ON-SITE SEWAGE DISPOSAL SYSTEM
 HOWARD COUNTY HEALTH DEPARTMENT
 BUREAU OF ENVIRONMENTAL HEALTH
 3525-H ELLICOTT MILLS DRIVE, ELLICOTT CITY, MD 21043

Approved Septic System Plan
 Howard County Health Department
 Revised - Field located Well

RE: **STOP WORK ORDER**
Fox Creek, Lot 5
12325 Fox Meadow Lane
BP # B00139280

Re: Fox Creek Lot 5 Well Variance
12325 Fox Meadow Lane
B00139280

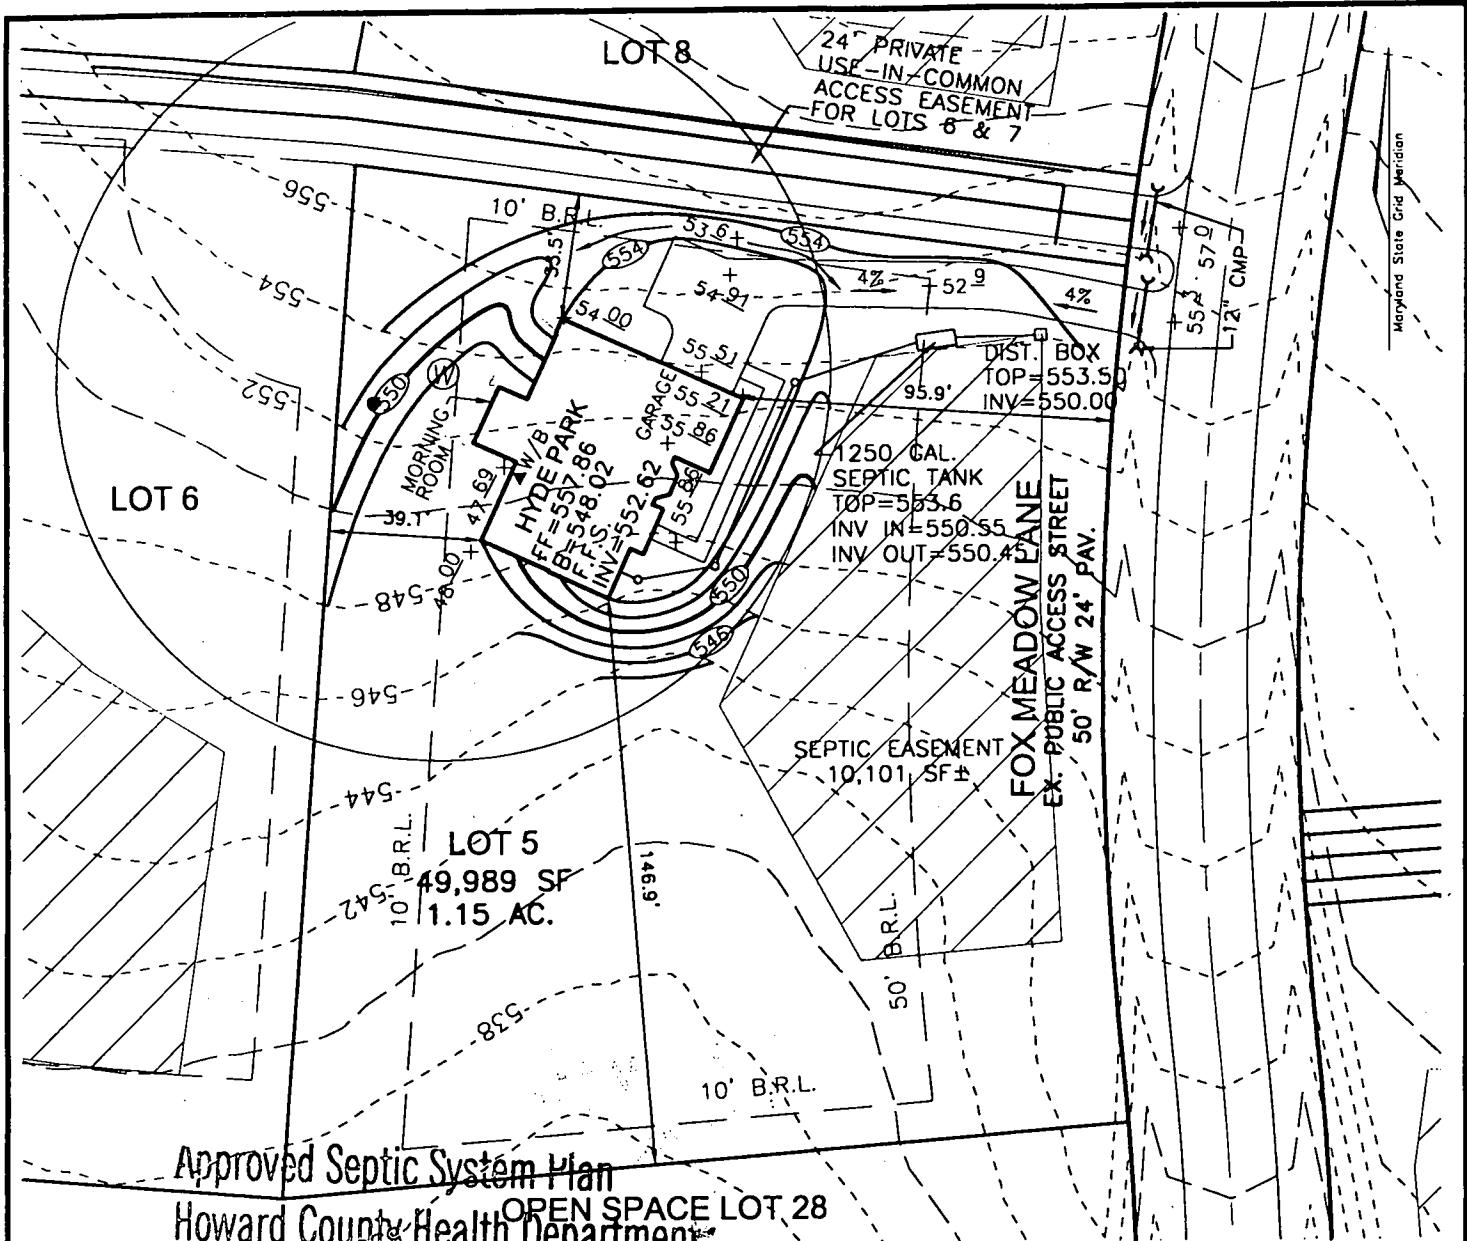
* 3/17/04 Review of well location identified by SAN. DOES NOT MATCH "STAKED By Surveyor" Location

PRE-CONSTRUCTION 7/9/03 SRA started Can't make fall to P.B. as shown on B.P. Locate D.B. to other side of SRA ST. to be relocated also.

INSTALLATION Install 40'/45'/50'/50'/55" trenches on contour. Well is 13' off back of house, also changes well radius (SO)

Approved Septic System Plan
Howard County Health Department

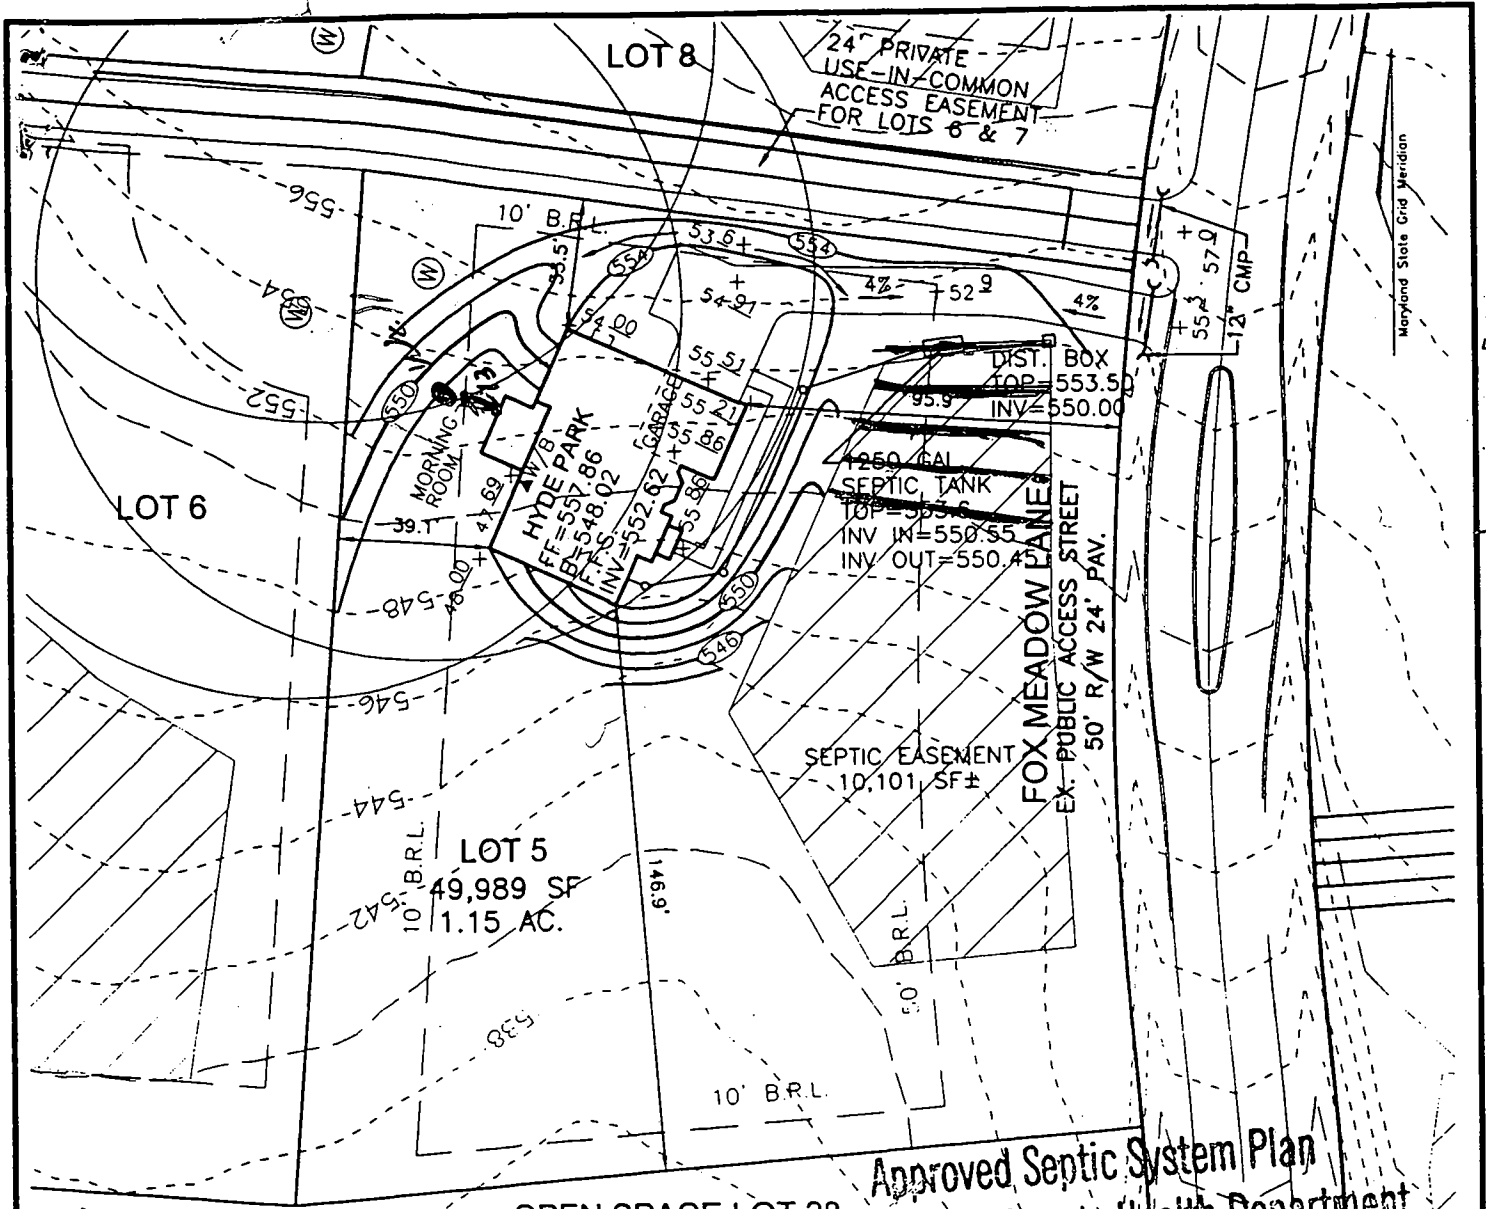
1-30-03
2 1/2" cover on S.T.
~ 3' cover on d. box
(KN)

FOUNDATION LOCATION

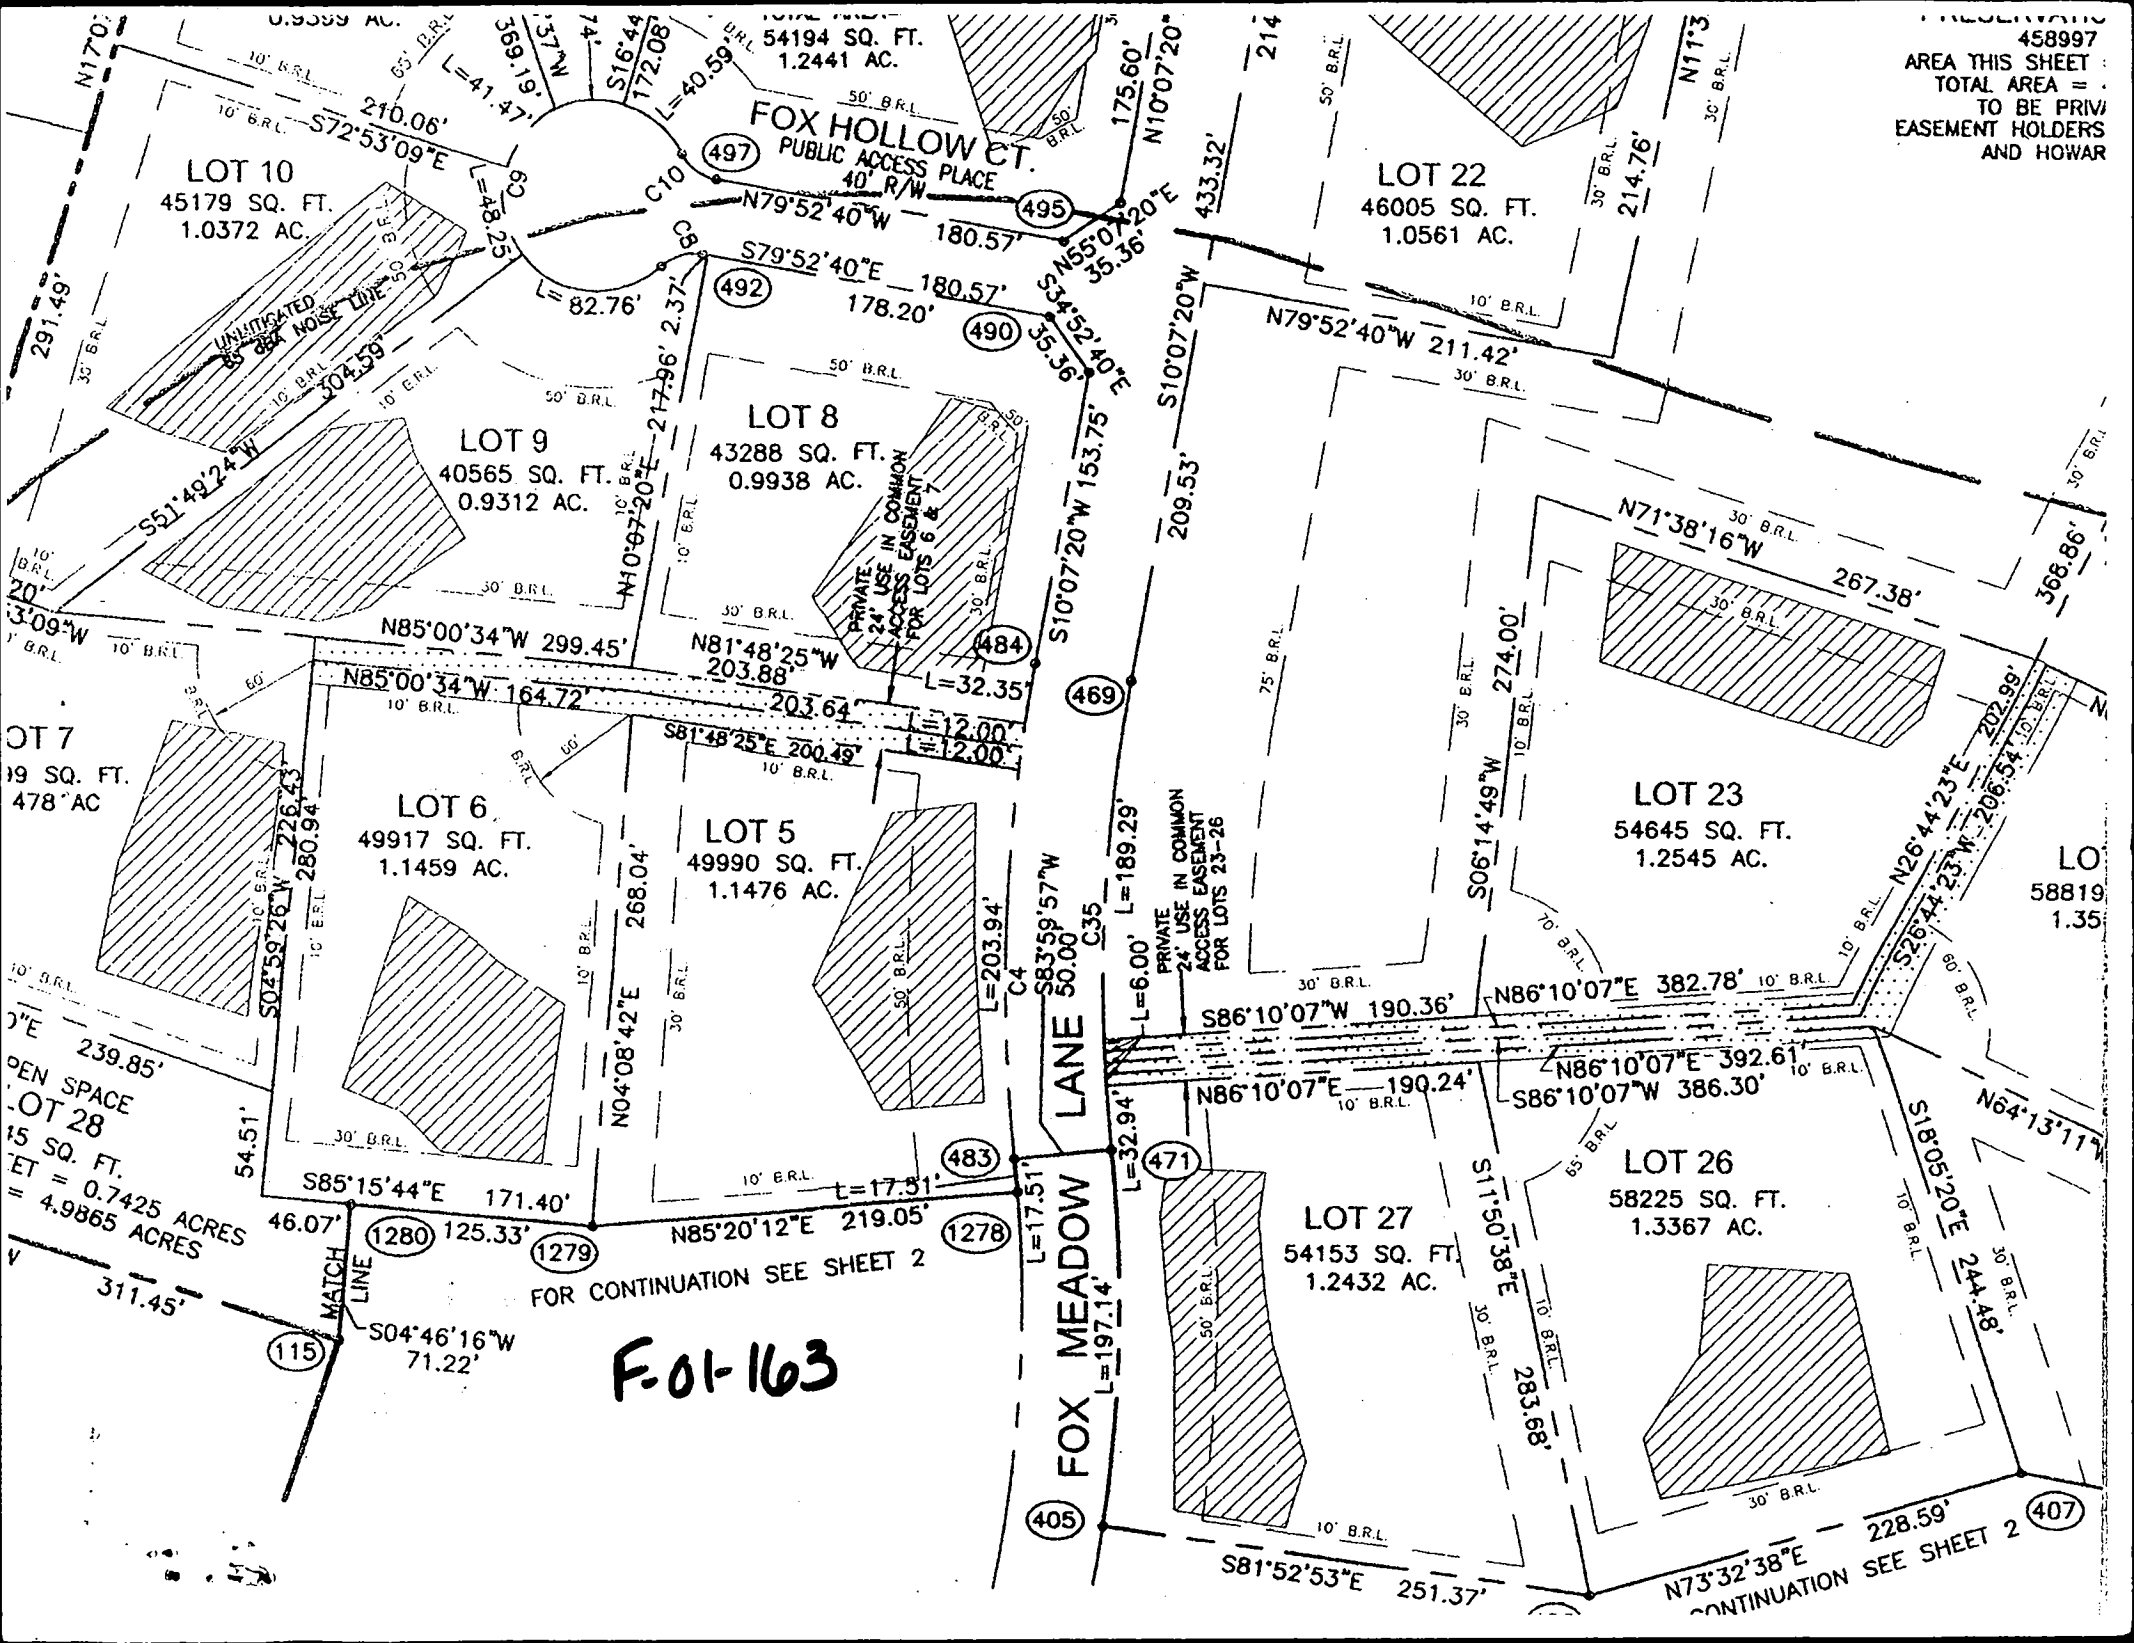
*6/25/03
Wall Check
O.K. BB*
